U.S. Department
of Transportation
**Federal Highway
Administration**

In Reply Refer To:
HSA-10/SS-143

Thank you for your letter of August 14, 2006, requesting the Federal Highway Administration's (FHWA) acceptance of your company's "i-Stop®" solar-powered transit stop assembly as a breakaway sign support system for use on the National Highway System (NHS). Accompanying your letter were drawings of the "i-Stop®" system, and information on the Xcessories Squared "Kleen Break" coupler breakaway mechanism. You requested that we find the signage system incorporating the "i-Stop®" and the "Kleen Break" acceptable for use on the NHS under the provisions of the National Cooperative Highway Research Program (NCHRP) Report 350 "Recommended Procedures for the Safety Performance Evaluation of Highway Features."

INSTALLATION OVERVIEW, i-STOP ON BREAKAWAY BASE

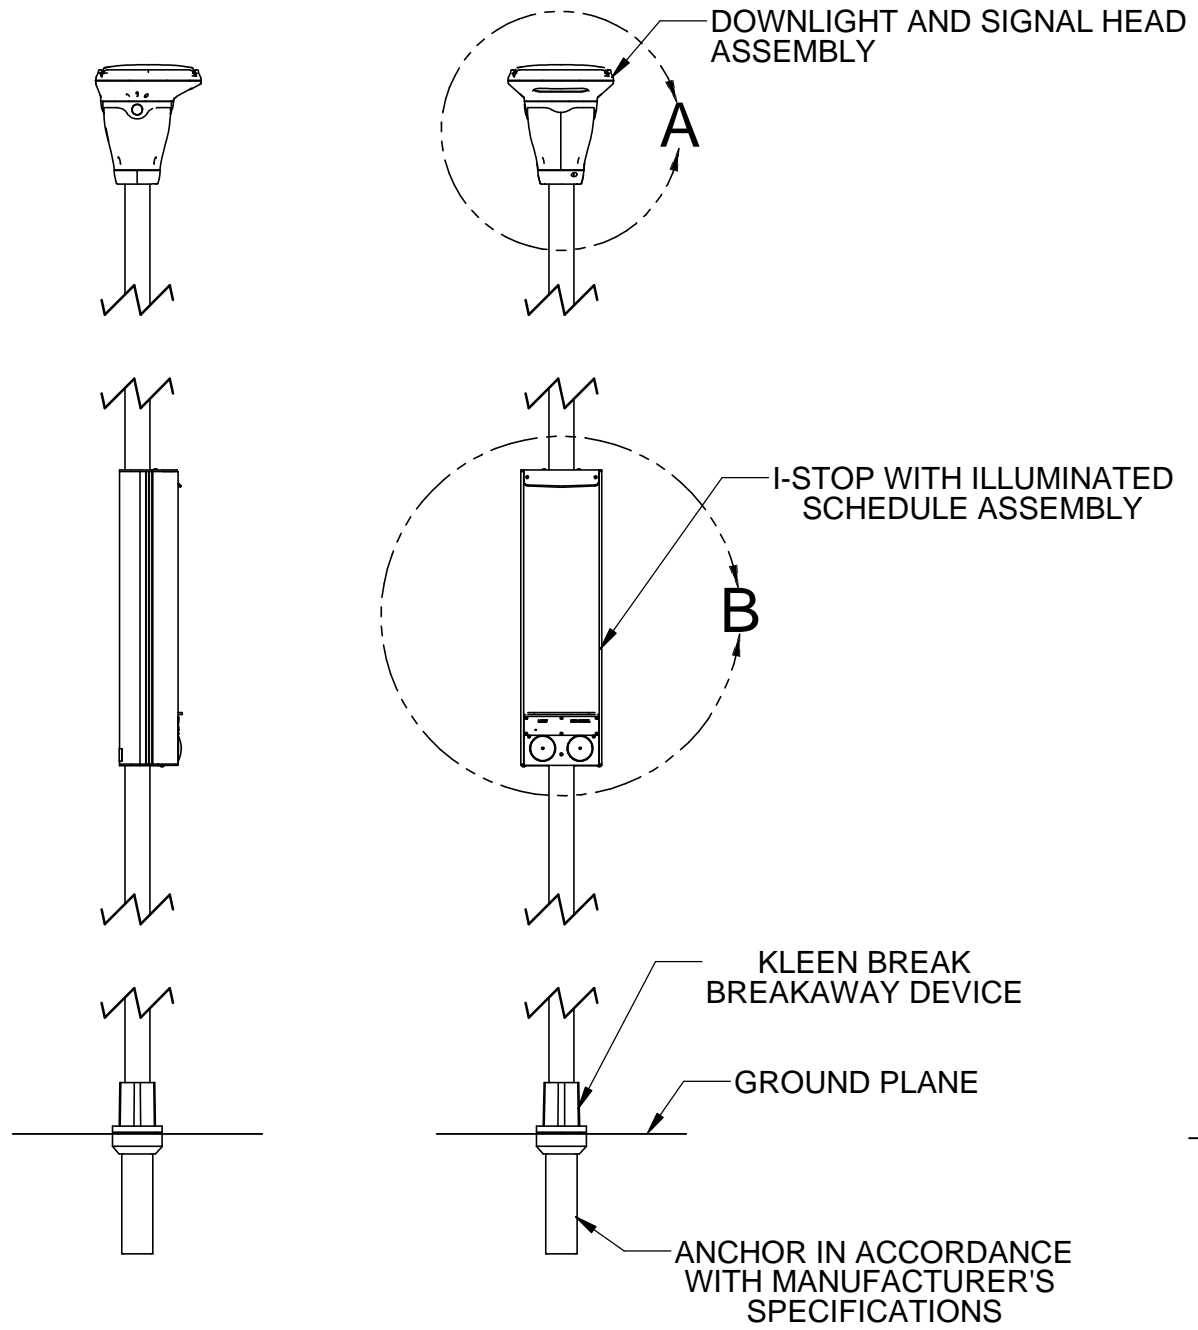
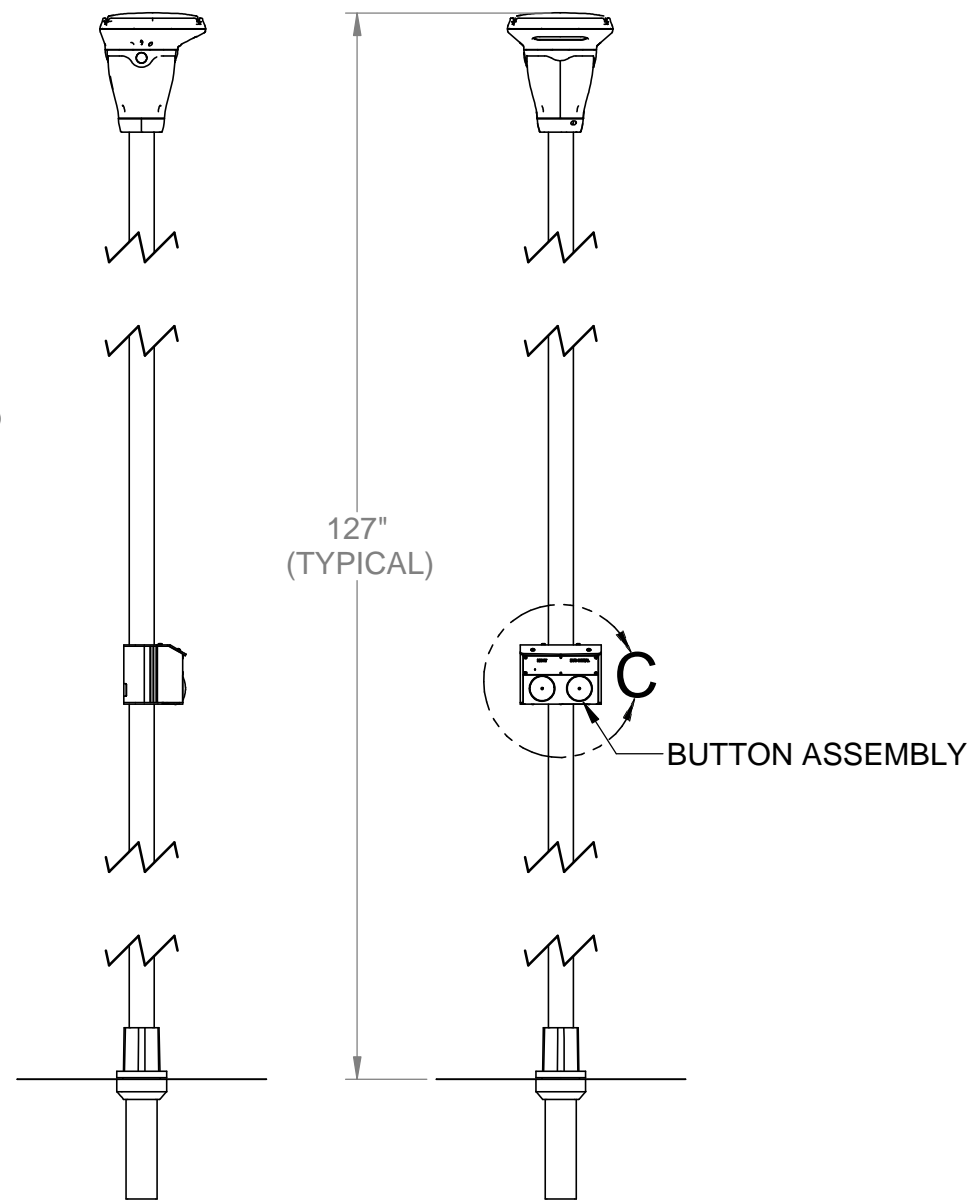
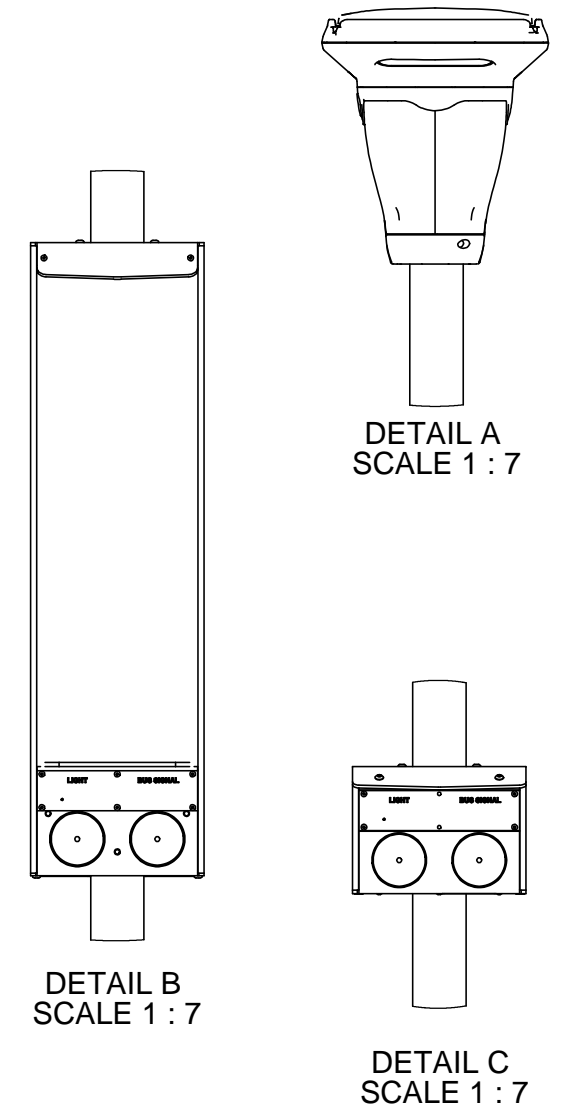
Because the weight of the various components of the "i-Stop®" system weigh less than 50 pounds and are securely affixed to steel poles mounted on crashworthy breakaway supports, the devices described above and shown in the enclosed illustrations for reference are acceptable for use as test level 3 devices on the NHS under the range of conditions tested, when proposed by a State.
